**LONDON ASHFORD AIRPORT (LYDD):
RESPONSE TO CONSULTATION, SUPPLEMENTARY
ENVIRONMENTAL INFORMATION AND STATEMENTS
TO INFORM (October 2007)**

COMMENTS ON AVIATION OPERATIONAL ASPECTS

Report No. 07/118/LAAG/3

Appendix 7 of SEI Volume 3B, Appendices 15.1 (Community Noise Impacts – Runway Extension) and 15.2 (Community Noise Impacts – Terminal Building) [annotated with references to Table 1 above]

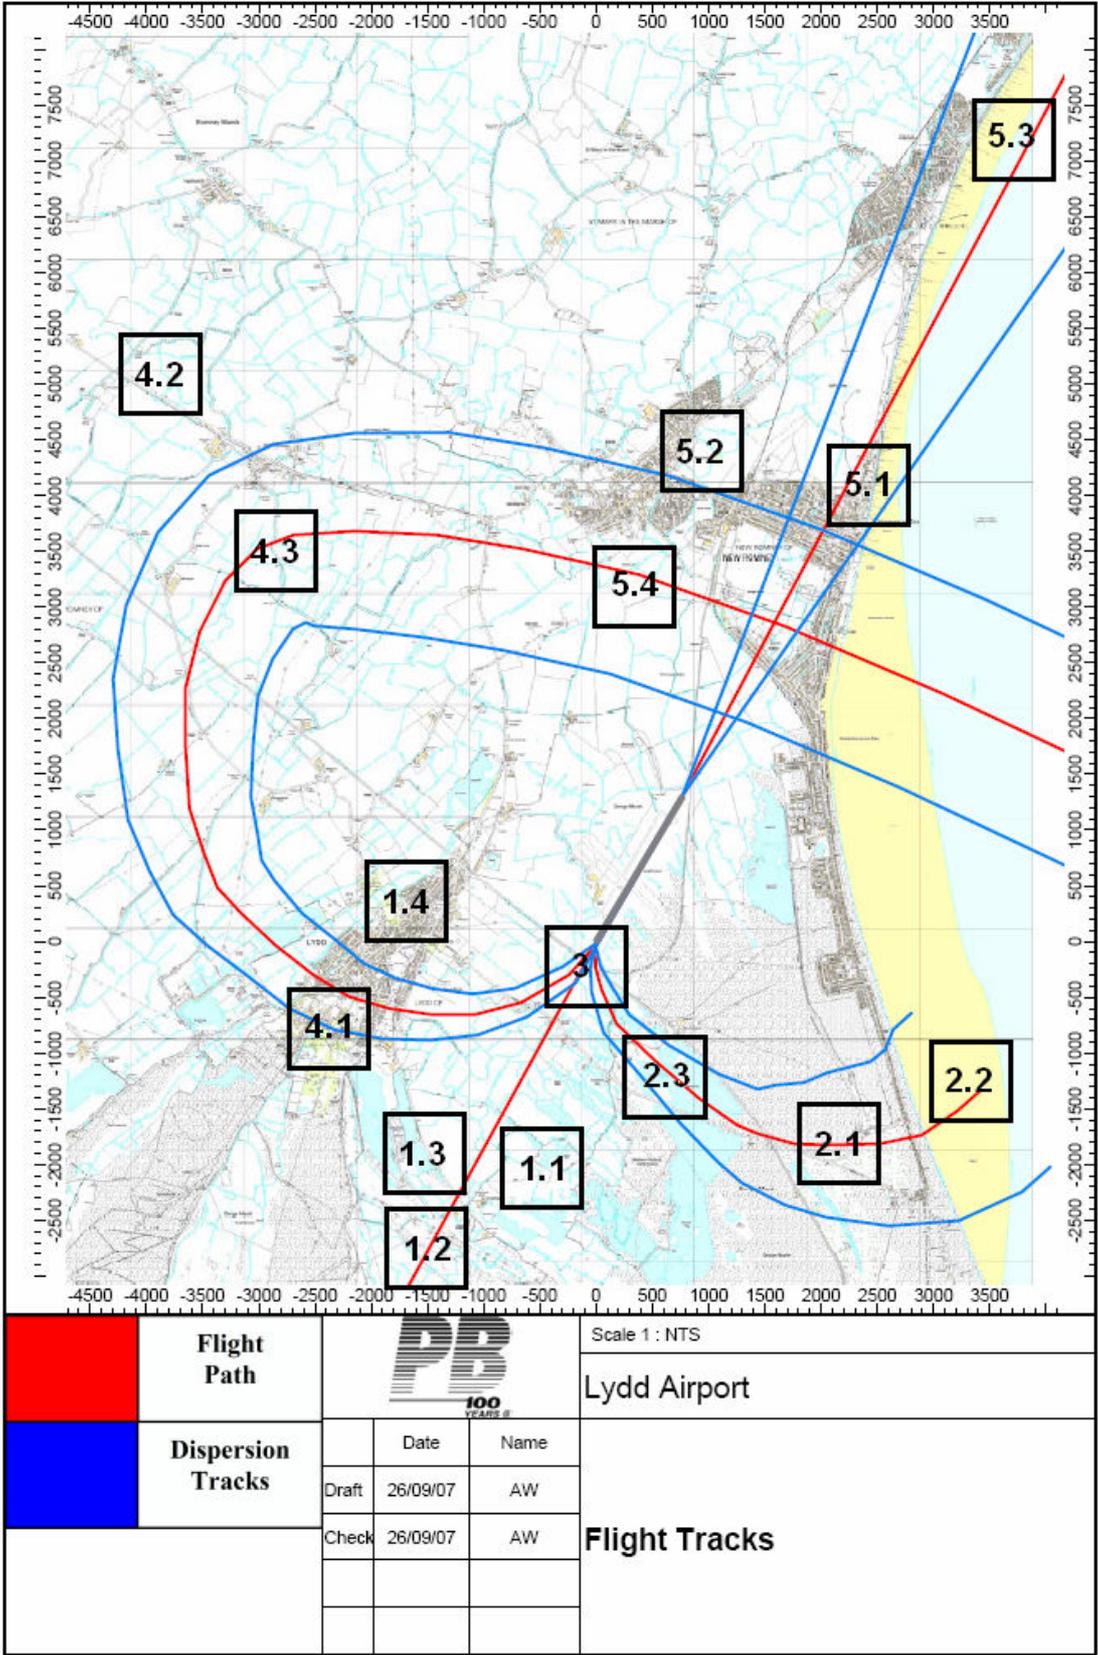
4.2 Table 1 below sets out our comments on the Flight Tracks map from Appendix 7 of the SEI Appendices 15.1 and 15.2, which is reproduced at Appendix B of this report, annotated with the reference numbers from Table 1 below. Further details on some of these points are raised in the subsequent paragraphs.

<i>Ref</i>	<i>Aspect</i>	<i>Remarks</i>
1.1	Approach from/departure to SW	No blue 'dispersion tracks' shown for this direction – why not?
1.2		Depiction of arrivals from/departures to south west assumes flights are possible through the Lydd Range airspace, but no figures given in text for assumed availability of range airspace

1.3		All arrivals from/departures to south west are shown continuing in a straight line – why no turns to/from the west?
1.4		No illustration of circling approaches to runway 03 – the only possible inbound IFR flight path when the wind favours runway 03.

2.1	Left turns on departure runway 21	All depicted flight tracks would infringe the Dungeness power station restricted airspace (1.5nm radius special dispensation for Lydd traffic). Is this simply a mapping error, or is it assumed that all aircraft following these flight paths will have climbed above 2000 feet before reaching the boundary of the airspace?

2.2		Depicted flight tracks cease shortly after crossing the coast. Where do these aircraft go subsequently? Do any cross back over the coast over Lydd-on-Sea/Greatstone/Littlestone? If they continue out to sea how are they integrated into en route airspace?

2.3		SEI continues to claim that airliners up to BAe146 size will all turn left on departure from runway 21. LAA should provide analysis of feasibility of this manoeuvre for all assumed aircraft types.
3	Departures runway 21 (general)	Departures are shown commencing a turn immediately from the departure end of the runway. LAA should provide analysis of feasibility of this manoeuvre for all assumed aircraft types.

4.1	Departures runway 21 (right turn)	Left hand 'dispersion track' is depicted infringing the northern corner of the Lydd

Range danger area. How many infringements of the range are assumed?
4.2		Only route shown is for departures to the south east. What flight path do departures in other directions follow?
4.3		Flight path takes a sharper turn when north west of the airport. What is the purpose of this and what assumptions were made about the aircraft's ability to fly as sharp a turn as this?
5.1	Arrivals from/departures to north east	Depicted flight path appears to follow the inbound ILS track; however outbound flights from runway 03 will not follow the ILS path, but will generally climb straight ahead initially – 5° to the east of the inbound ILS track.
5.2		Inbound NDB flight path for runway 21 is not shown
5.3		All departures from runway 03 are depicted climbing straight ahead to at least Dymchurch. What about aircraft routing to destinations other than to the north east?

Annotated excerpt from Runway Extension ES, Figure 3.3, showing nuclear power station restricted airspace and Lydd Range danger area, as depicted in the ES (in red) and in their correct locations* (in purple).

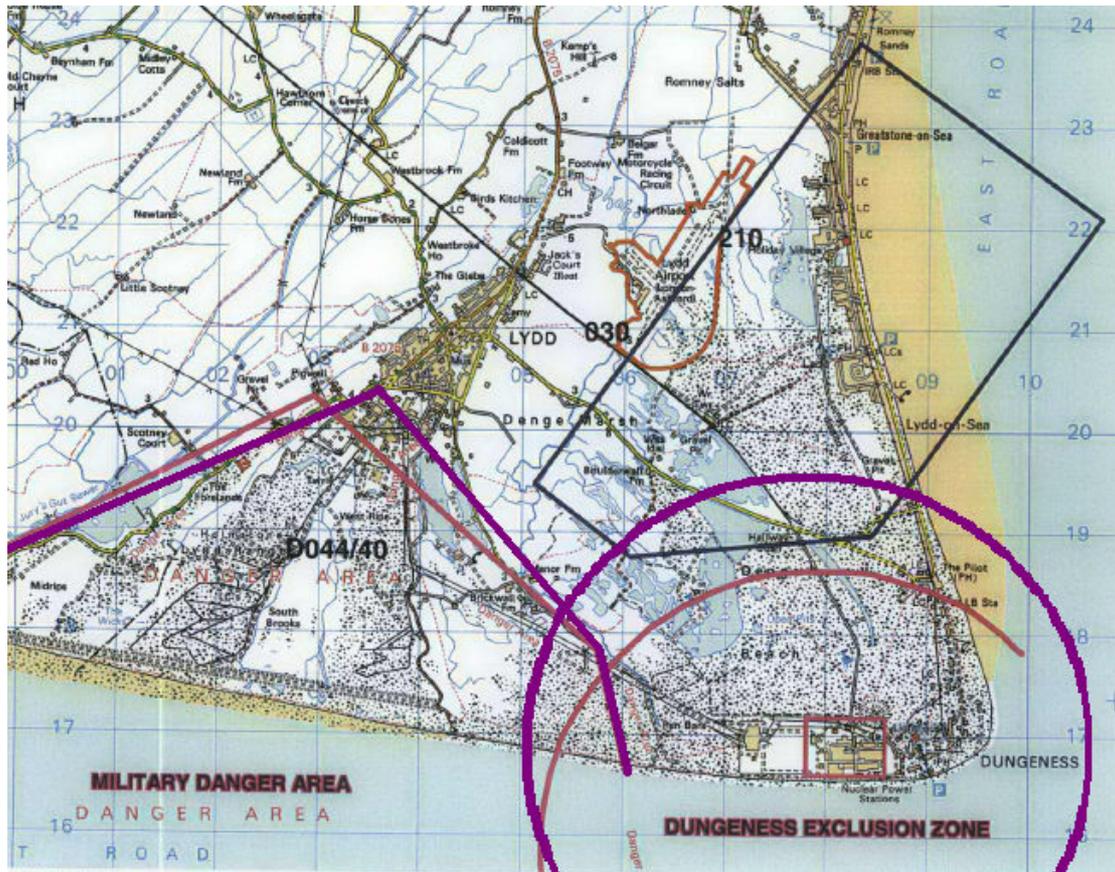
4.4 Figure 3.3 of the Runway Extension ES, which portrays the boundaries of the Lydd Range Danger Area and the Dungeness Power Station restricted airspace incorrectly, has not been corrected in the SEI (see annotated copy of Figure 3.3 at Appendix C). This continued error means that all of the assumed left turn departures from runway 21, and some of the right turn departures, are shown infringing the danger area or restricted airspace.

Fig 3.3 shows the restricted zone incorrectly. It appears to have the correct radius, but the centre point is clearly in the sea approximately 1km south of the correct location. Consequently the depicted "current flightpath" is incorrect since in its depicted location aircraft would be routinely flying closer than 1.5nm to the power station.

Circuit pattern is not aligned with the runway. Right-angle corners are not representative of aircraft turning flightpaths.

Boundary of D044 is shown incorrectly, further south west (away from the airport and the town of Lydd) than it actually is, by some 500 metres.

The effect of all these errors is to portray the airport as being less restricted than it is.
